Subject: James A. FitzPatrick Nuclear Power Plant
Docket No. 50-333
Recirculation System Welds

The enclosure to this letter responds to questions which were
transmitted to us in a telephone conversation on October 31, 1984.
Attachments 1 to 4 refer to question 1 of the enclosure.

Recirculation System Welds

James A. FitzPatrick Nuclear Power Plant
Docket No. 50-333

ATTACH. #1

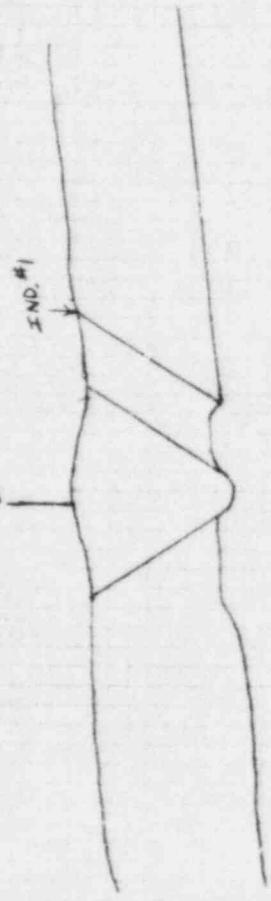
In 1977, General Electric Co. performed an inspection on the subject weld as did Ebasco in the Summer, 1983 outage. These inspections resulted in the findings of indications which were deemed to be geometric in origin. The plots made were based on a projected OD/ID profile (flat-topped weld crown and ideal ID profile) and did not reflect the actual conditions. In addition to this, the exams were performed using full-length 45° wedges which prevented the shoe from going beyond the "butt-up" position which is necessary to obtain a meaningful examination. The shortened (EPRI-modified) wedges were not available until late (fall) 1983. Replotting of the 1983 data using 1984 ID/OD profile information (Attachment #1) shows that weld geometry was the cause of the indication recorded by Ebasco. In the September, 1984 outage, further investigation was performed by the NYPA and Ebasco Level III's including examination of OD profile. As a result it was determined that a 45° exam, even if performed with the EPRI-modified wedges, would not examine the area-of-interest (the heat affected zone between the counterbore and root) due to the O.D. configuration (See Attachment #2). Based on this information and the projected exit point vs. area-of-interest relationship, a 60° exam was performed on weld 12-23. The remainder of the welds which have a similar OD profile, were also examined using a 60° shear wave if the 45° exam proved inadequate. As a result of these inspections, all pipe-safe end welds which were inspected in 1983 were reinspected (i.e., welds 12-1, 12-7, & 12-75). These inspections, utilizing the 60° technique, revealed that these three weldments were free of reportable indications. Attachment #3 is a resubmittal of weld 12-23 data which was generated in 1983 and Attachment #4 is the 1984 data.

REFERENCED WELD & BASED ON 1983 EST. AS MEASURED FROM S.E. SIDE - TO - ROOT RELATIONSHIP.

SE-PLOT OF 1983 DATA USED TO GO PLOT ESTABLISHED IN 1989

NOTE: Full-length 45° Shears were used in 1983 prohibiting the side to go beyond the "built-up" position so as to obtain a meaningful estimation. Short-hopped (EPRI-MED/150) measures were available to plants knowledge until late (fall) 1983.
